Wellington to Hutt Valley Walking and Cycling Link

Concept Design Stage Safety Audit

Second draft 28 March 2014

Figure 26: Crosses shared path

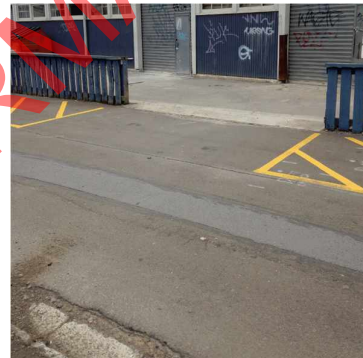
The RCA should be controlling informal access across the shared path. The SAT observed an area where trucks are clearly turning across Hutt Road, over two sections of kerb and channel and across the shared path. Every access way should be formalised and marked appropriately.

Frequency Rating: <i>Crashes are likely to be</i> Common	Severity Rating: <i>Death or serious injury is</i> Very likely
Designer Response: <u>The proposed design takes into consideration most of the points noted by the safety auditors. Those that have not been incorporated will be added. The exception is the banning of the right turning movements. Provision of the U-turn facility would not be practical and introduce an unnecessary safety hazard. The provisions made in the proposed design to enhance the safety of the shared path users include large gaps between the parked at kerb vehicles to make the cyclists and pedestrians on the path visible to the turning drivers. It has to be noted that the driveways in Hutt Road are infrequent. NB. The details of what we propose to do are discussed in the Business Case Report, but not in the two documents submitted to the SAT. The proposed design takes into consideration most of the points noted by the safety auditors. Those that have not been incorporated will be added. The exception is the banning of the right turning movements. Provision of the U-turn facility would not be practical and introduce an unnecessary safety hazard. The provisions made in the proposed design to enhance the safety of the shared path users include large gaps between the parked at kerb vehicles to make the cyclists and pedestrians on the path visible to the turning drivers. It has to be noted that the driveways in Hutt Road are infrequent.</u>

Figure 33: Forest of poles in path

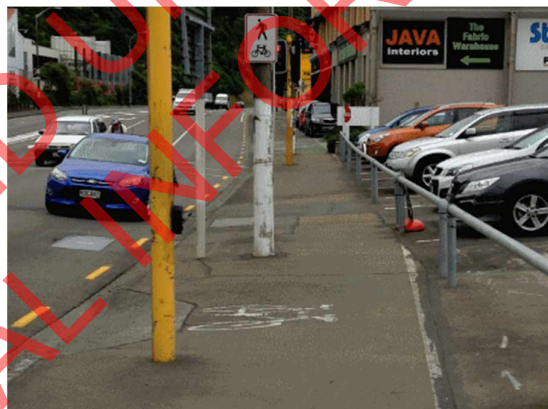
There are a plethora of service utility poles along the Spotlight frontage creating a very narrow section of shared path. It is understood that the street lights are being relocated but there are (3) traffic signal poles located in the centre of the path, constricting the width here.

Frequency Rating: <i>Crashes are likely to be</i> Occasional	Severity Rating: <i>Death or serious injury is</i> Very likely
Designer Response: We agree with the auditors comments. The objective is to provide a 3m dedicated cycle path; all obstructions at Kaiwharawhara should be relocated to be clear of the path. The culvert widening could be undertaken at grade to clear the services. Further investigation should be undertaken during detailed design for the Spotlight Carpark entrance / exit.	
Safety Engineer: <input type="text" value="Click here to enter text."/>	
Client Decision: <input type="text" value="Click here to enter text."/>	
Action Taken: <input type="text" value="Click here to enter text."/>

Figure 36: Potential to widen path here

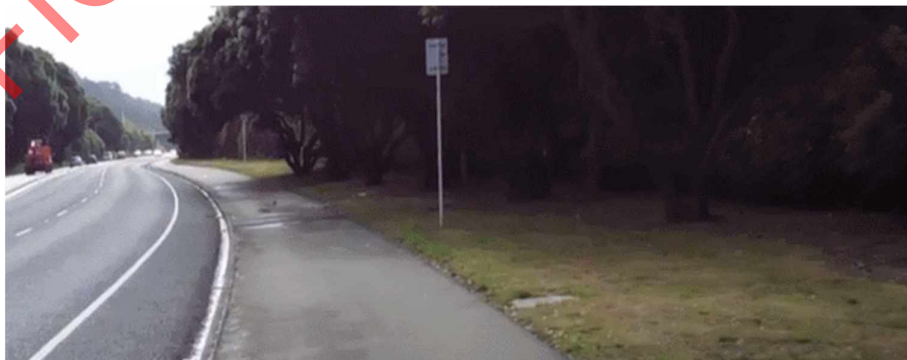
There are some areas along section 2 where the shared path can be widened without requiring land or relocation of fences, structures, trees etc...as seen in Figure 36.

Figure 49: Fence, poles, wire rope & W-Section constraints

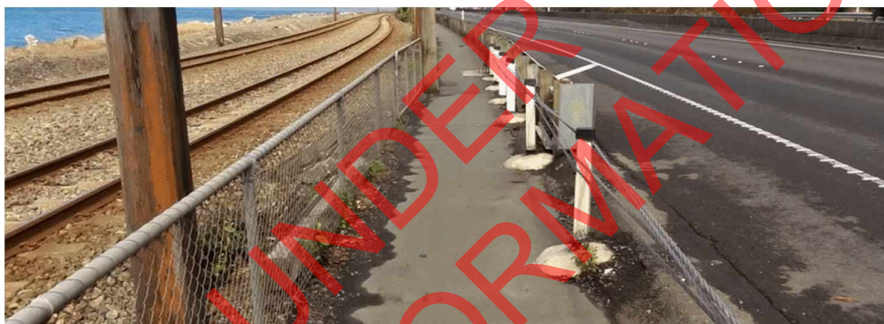
Figure 49 at CH 1,550 shows a section of path designed to be 1.8 m wide, however there may not even be enough space to achieve that unacceptable width.

Designer Response: AECOM's view is that Option 3 should be pursued in preference to Option 1. For Option 1 the minimum width of 2.5m would be sufficient if there are cyclists only, but no pedestrians. Such a width is achievable, with an exception of a few pinchpoints, which would be well signposted. Option 1 would not be attractive for pedestrians, so they are not likely to be on the path. The opportunities to refine Option 1 may be pursued in the event it becomes the recommended option (e.g. if Option 3 is rejected by the Transport Agency).
